METROPOLITAN GOVERNMENT OF NASHVILLE AND DAVIDSON COUNTY

Metropolitan Historic Zoning Commission
Sunnyside in Sevier Park
3000 Granny White Pike
Nashville, Tennessee 37204
Telephone: (615) 862-7970
Fax: (615) 862-7974

STAFF RECOMMENDATION
2818 Belcourt (512 32nd Avenue)
February 20, 2013

Application: New construction-infill
District: Hillsboro-West End Neighborhood Conservation Zoning Overlay
Council District: 18
Map and Parcel Number: 10406030700
Applicant: Peggy Newman
Project Lead: Robin Zeigler, robin.zeigler@nashville.gov

SITE PLAN

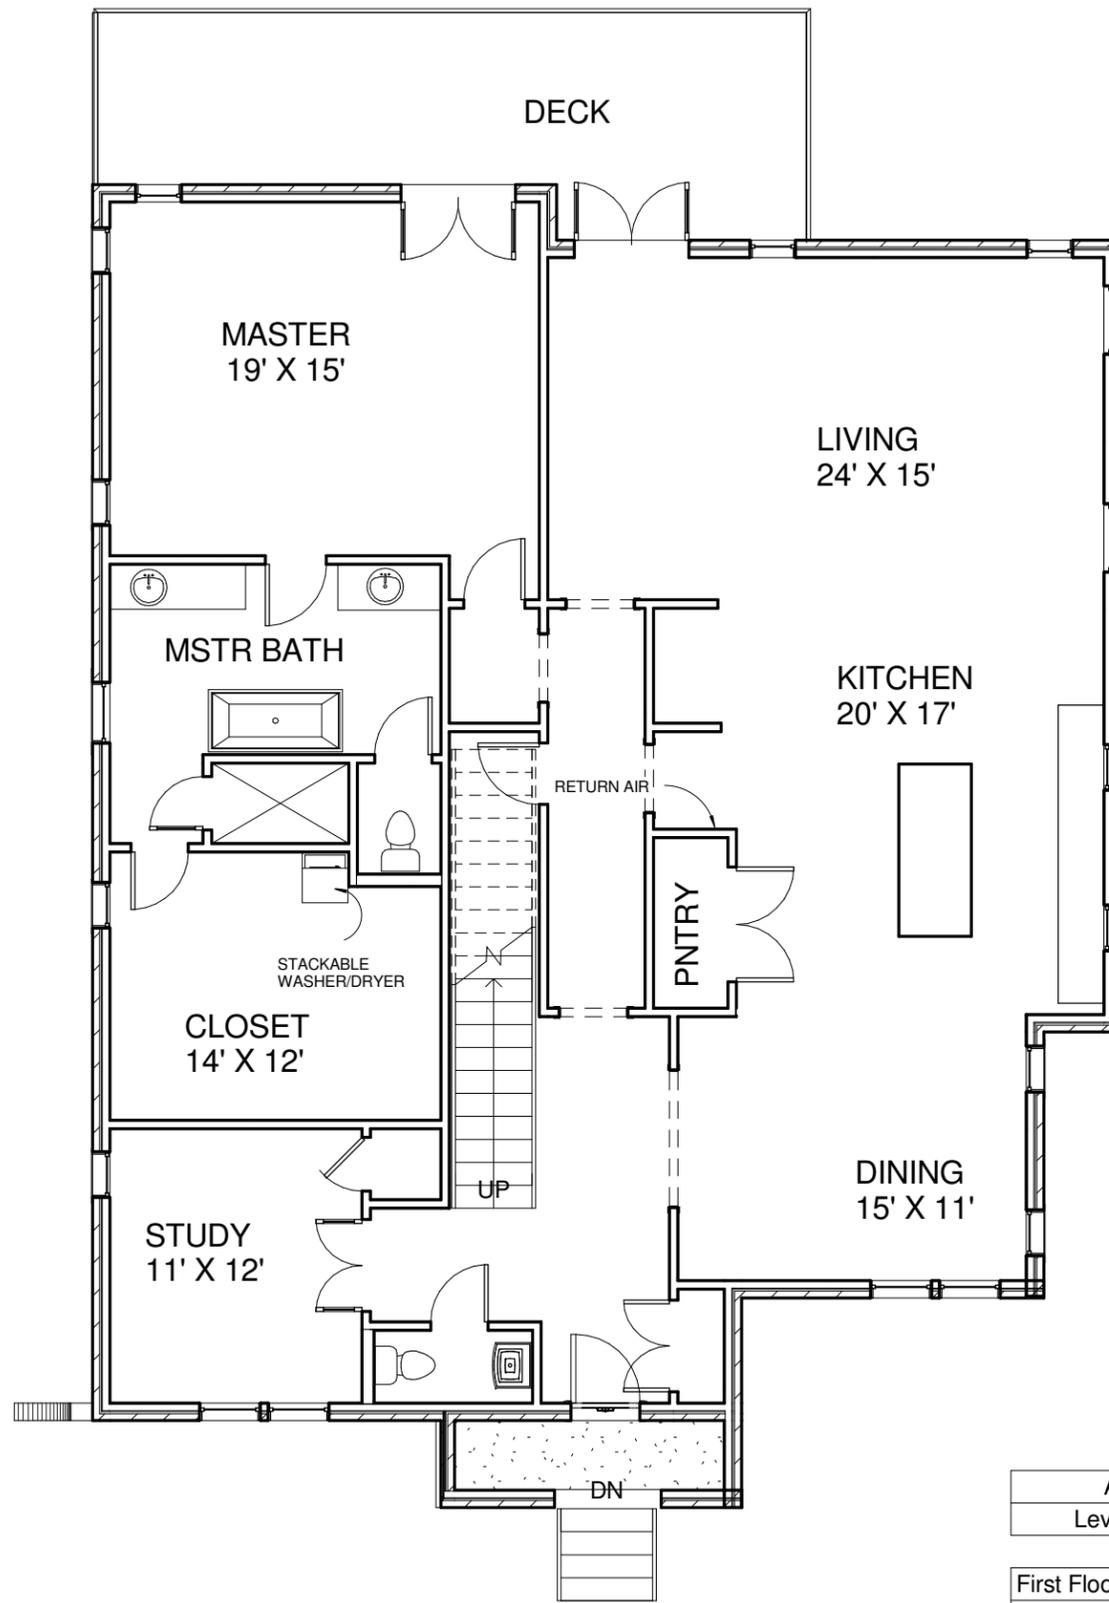
The building will face 32nd Avenue as will the proposed building to the right, and as does the existing buildings to the left and across the street. The main entrance will connect to the street with a walkway. Typically, walkways lead straight from the front steps to the street or sidewalk. This one is designed as an "s" curve in order to lead to a parking area in the front yard, parallel to the street. The Commission has only allowed for parking in the front yard when the grade was too steep to accommodate a driveway and there was no alley access. In this case, there is no alley access but there is a single-lane driveway leading from 32nd Avenue to an attached garage. (There is an existing curb cut on the far left of this lot which leads to the non-contributing house which currently faces Belcourt

Avenue.) Staff recommends removal of the front parking area and straight walkway. With this condition the project meets section II.B.f of the design guidelines.

512 32ND AVE FRONT ELEVATION

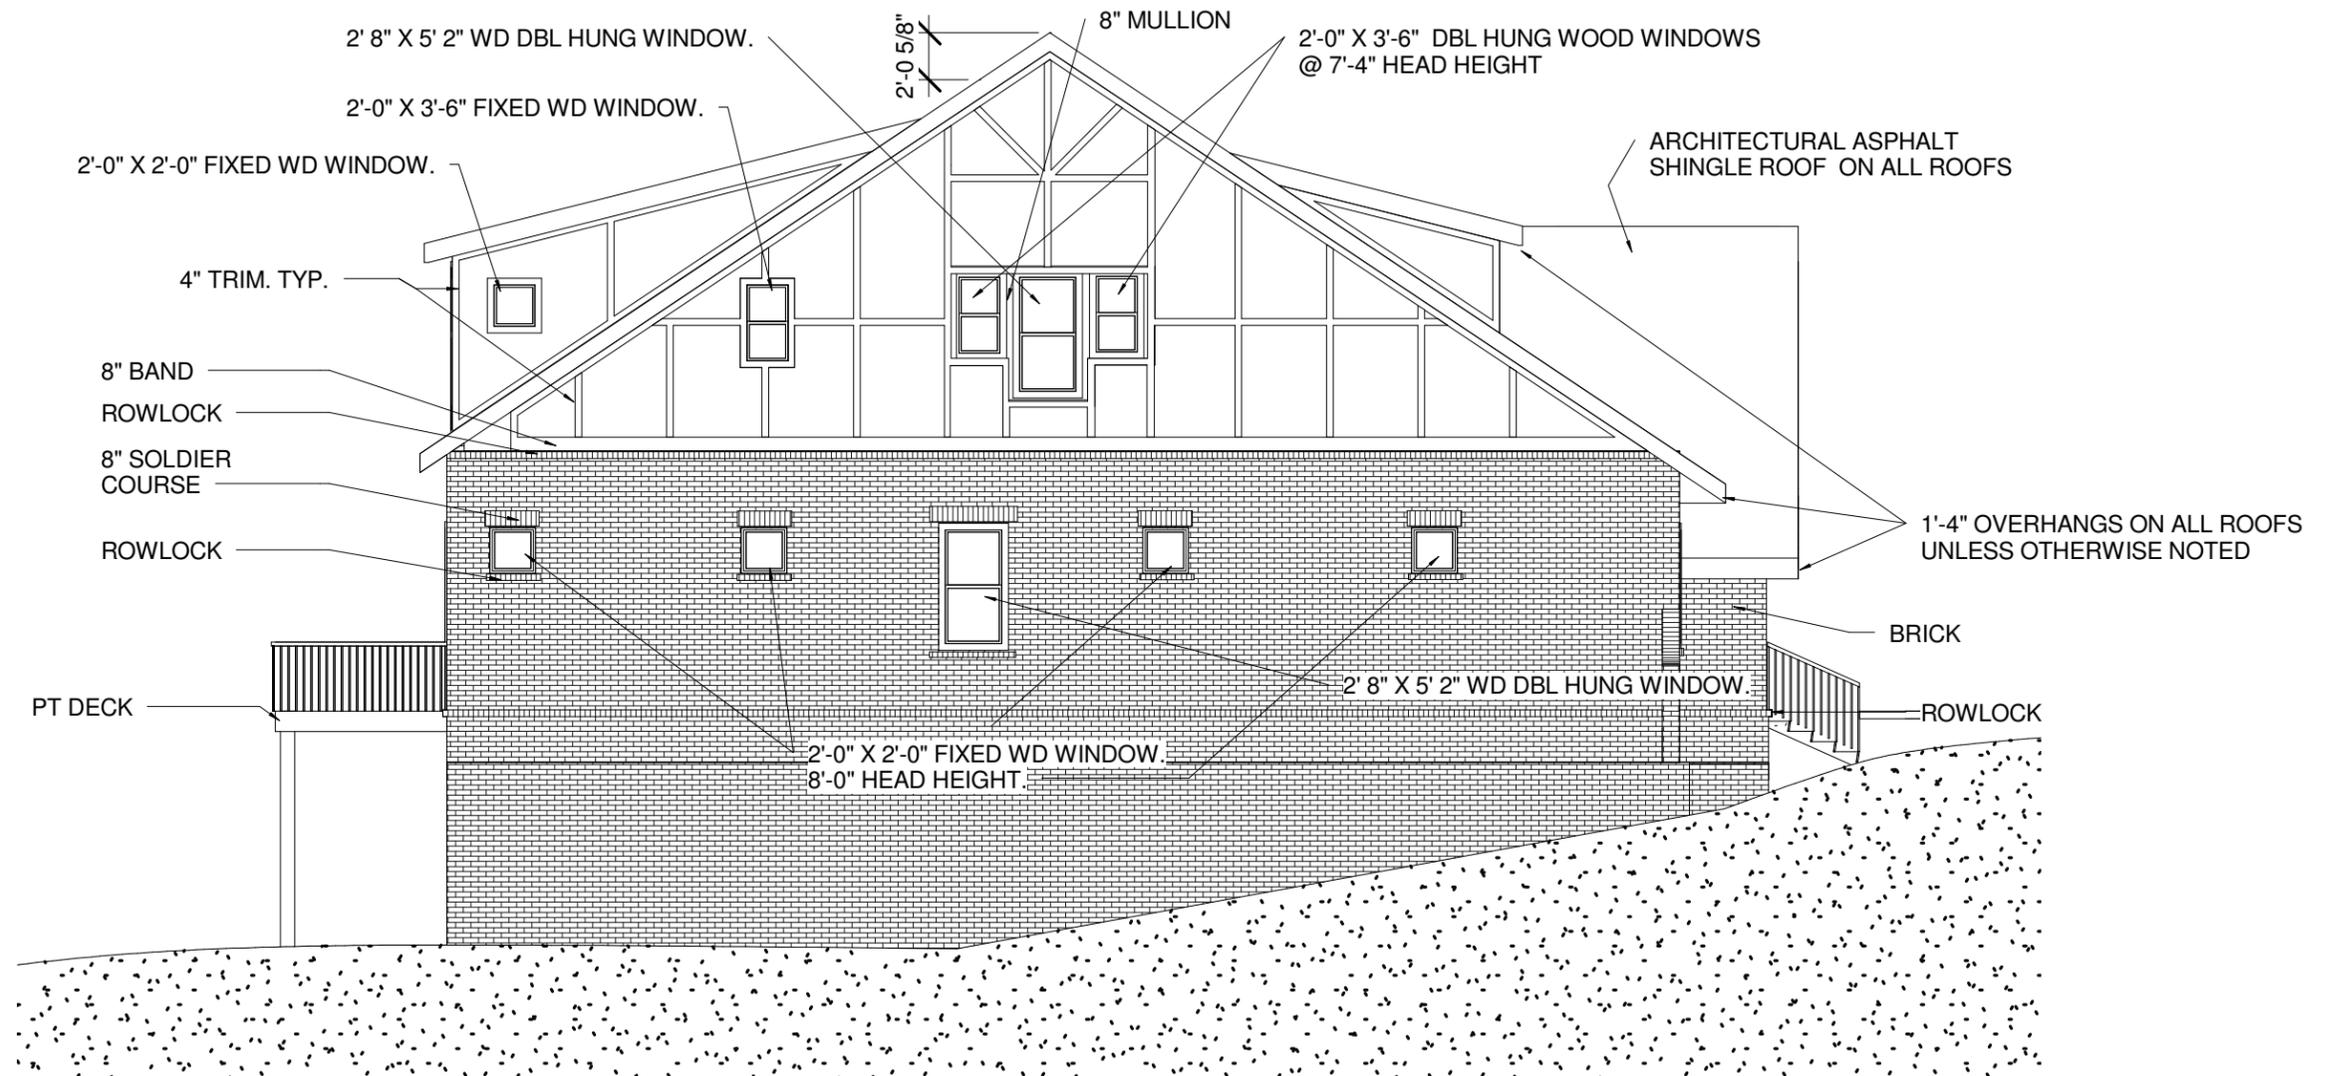
The lack of a distinguished foundation line will increase the perception of height but can be mitigated by changing materials at the foundation line, as typically seen on historic buildings.

The proportions of the majority of windows is twice as tall as they are wide, as found in the district. Staff recommends increasing the height of the shed roof dormer so that the dormer can accommodate more vertical windows rather than square windows. Mullions that are a minimum of four to six inches wide have typically been required on paired windows. The drawings note the mullions but do not show them. For clarity, Staff recommends a condition that the paired windows have a 4" mullion.

512 32ND AVE LEFT ELEVATION

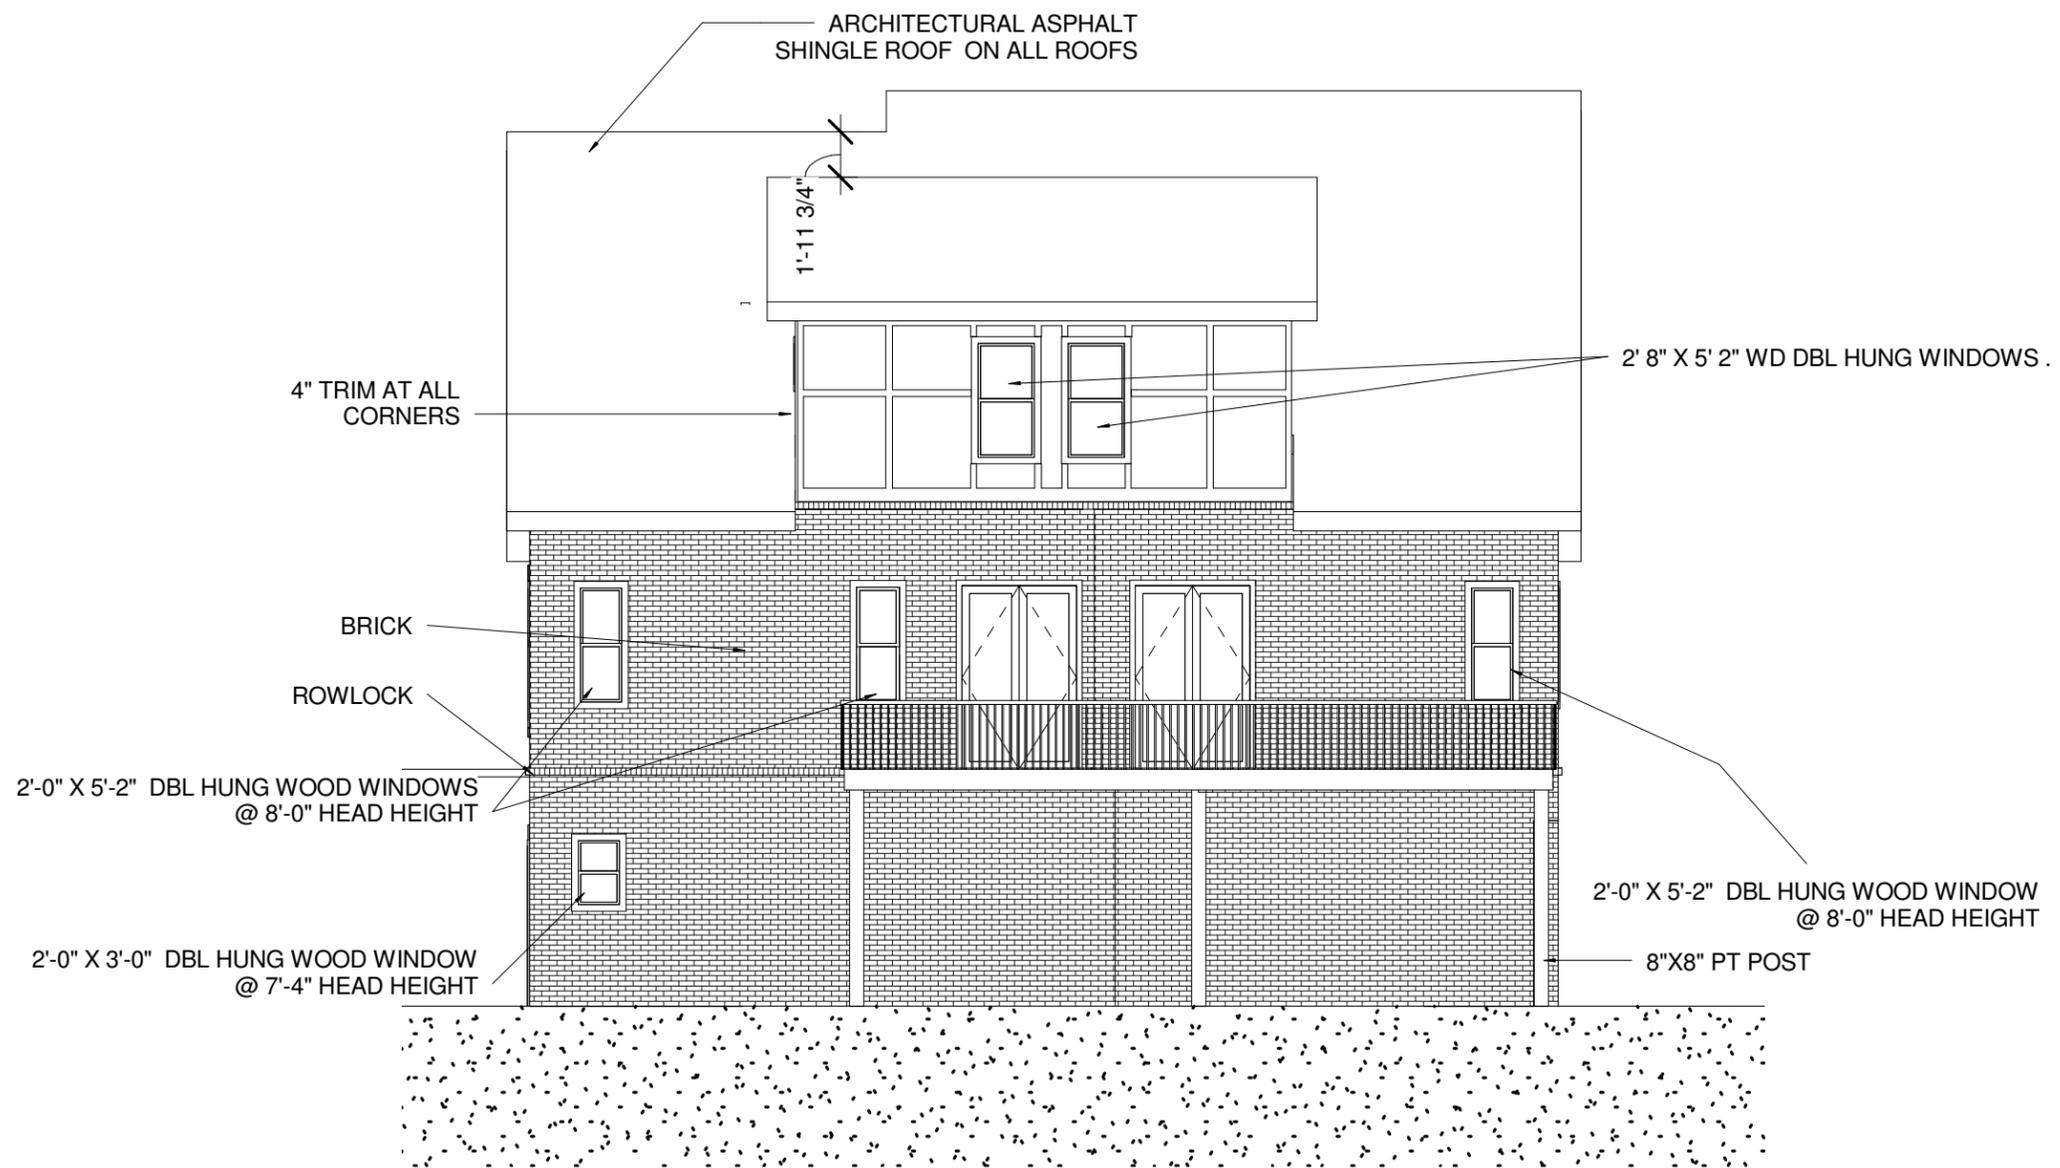
The rhythm of openings is similar to the historic buildings. The largest expanse without an opening or other visual break is only nine feet (9') with the exception of the left side, basement level. Staff recommends adding a window to this area.
